## CALIFORNIA COASTAL COMMISSION

## REVISED CONDITIONS AND FINDINGS

Application No.: 6-07-79

Description: Construction of an 1.8 mile segment of the Bayshore Bikeway consisting of a new 12-foot wide paved bike path on the unused railroad tracks on the Otay River Berm, two new steel truss bridges on top of the existing wooden railway bridges, fencing, signage, and relocation of the existing haul road for the South Bay Salt Works on the Main Street Dike to the railroad right-of-way to the north.

07/17/06  
Bayshore Bikeway - Western Salt Segment  
**FIGURE 3-7**

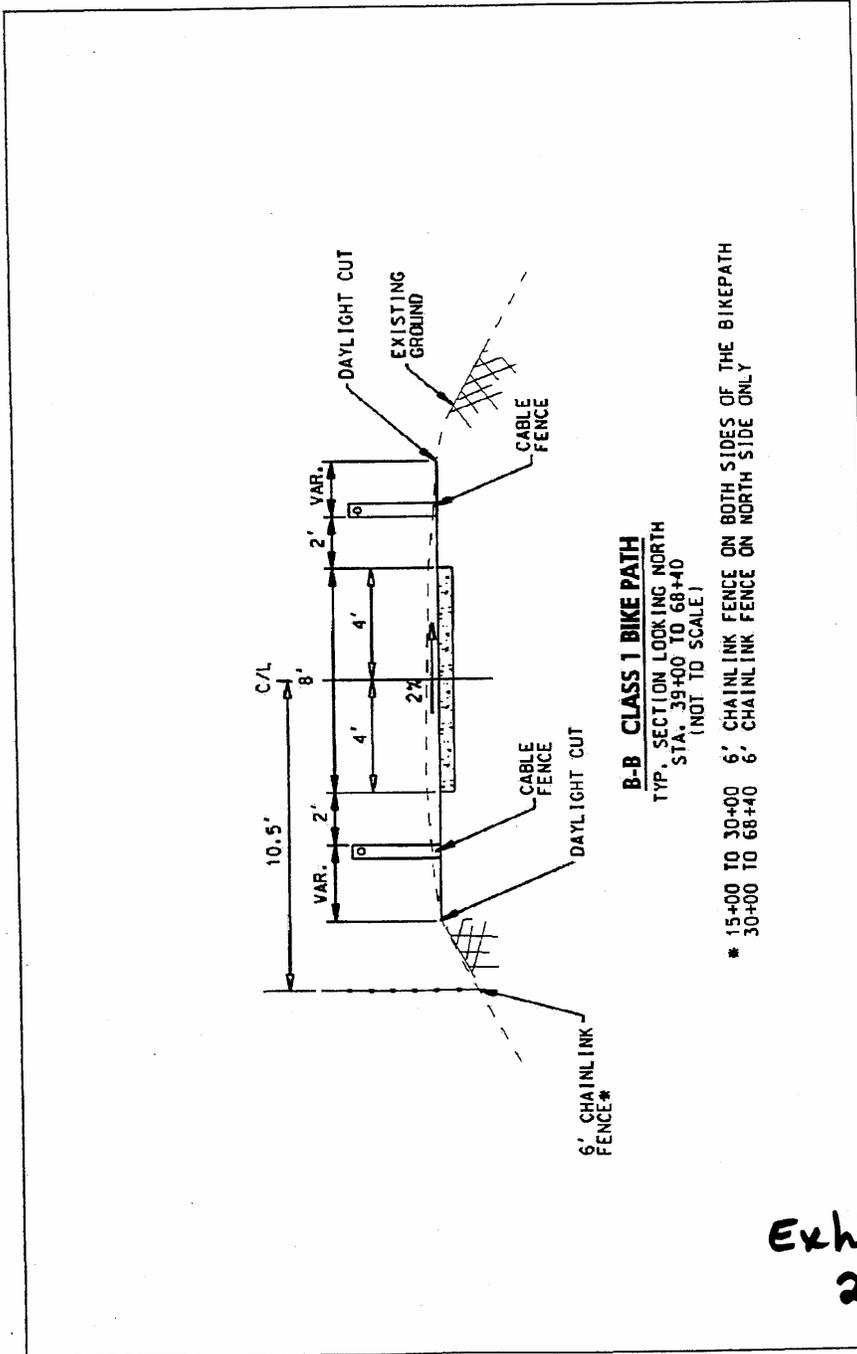
Ms. Kristen Forthner	3	Reporting Program, and construction plans should indicate that the silt fence will be constructed within the railroad right-of-way boundary.	FWS (Refuge)5 (cont'd)	RESPONSES TO COMMENT LETTER RECEIVED FROM UNITED STATES DEPARTMENT OF THE INTERIOR (FISH AND WILDLIFE SERVICE – SAN DIEGO NATIONAL WILDLIFE REFUGE COMPLEX), SIGNED BY ANDREW YUEN, DATED JULY 13, 2007 (cont'd)

(Sill Fence). The proposed sill fencing would be limited to within the MTS right-of-way (outside of the Refuge boundary). EIR Figure 3-7 has been revised to correctly reflect this condition.
